Part A

RADIO SPECIFICATION

Figure 5.1: Figure 3-1 Actual transmit modulation.

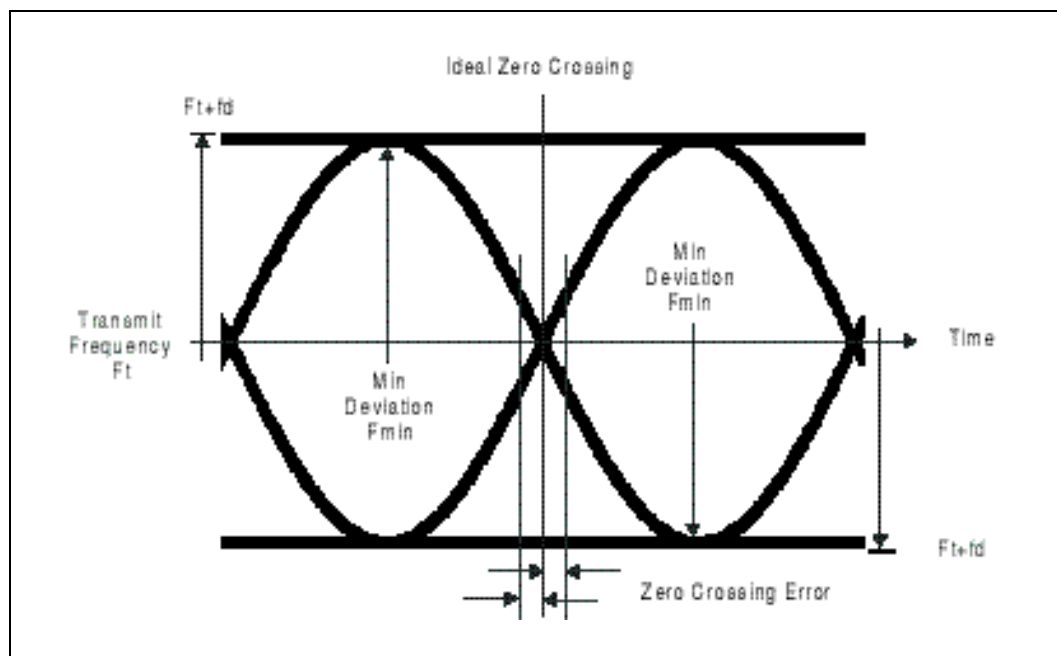
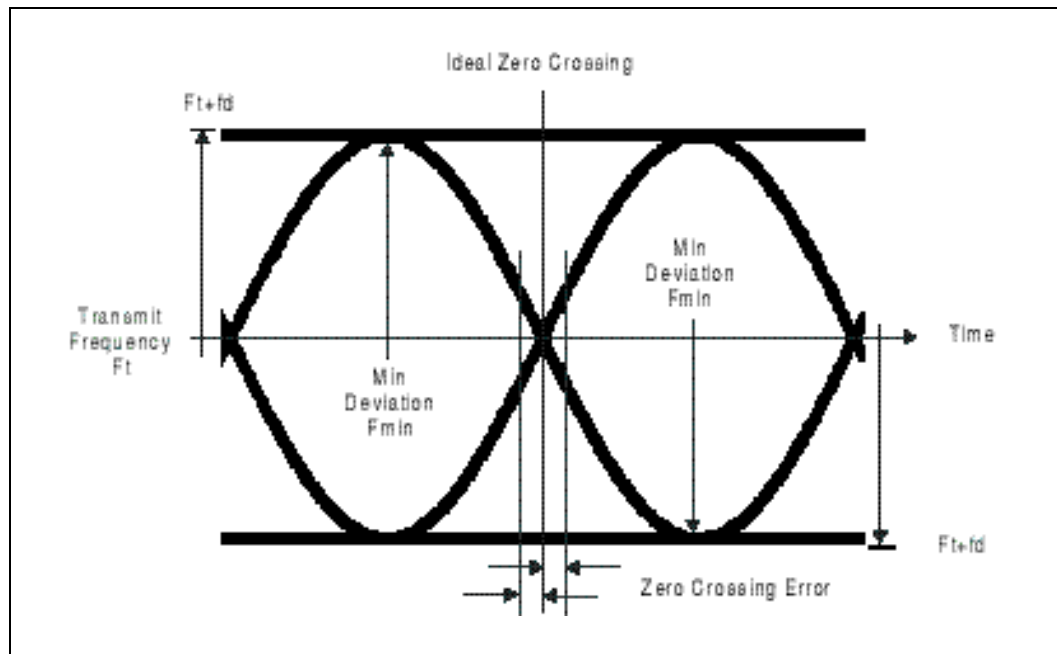
For each transmit channel, the minimum frequency deviation (F_{min} = the lesser of $\{F_{min+}, F_{min-}\}$) which corresponds to a -1010 sequence ~~should~~ shall be no smaller than $\pm 80\%$ of the frequency deviation (F_{t+fd}) which corresponds to a 00001111 sequence.

In ~~addition~~ addition, the minimum deviation shall never be smaller than 115 kHz.
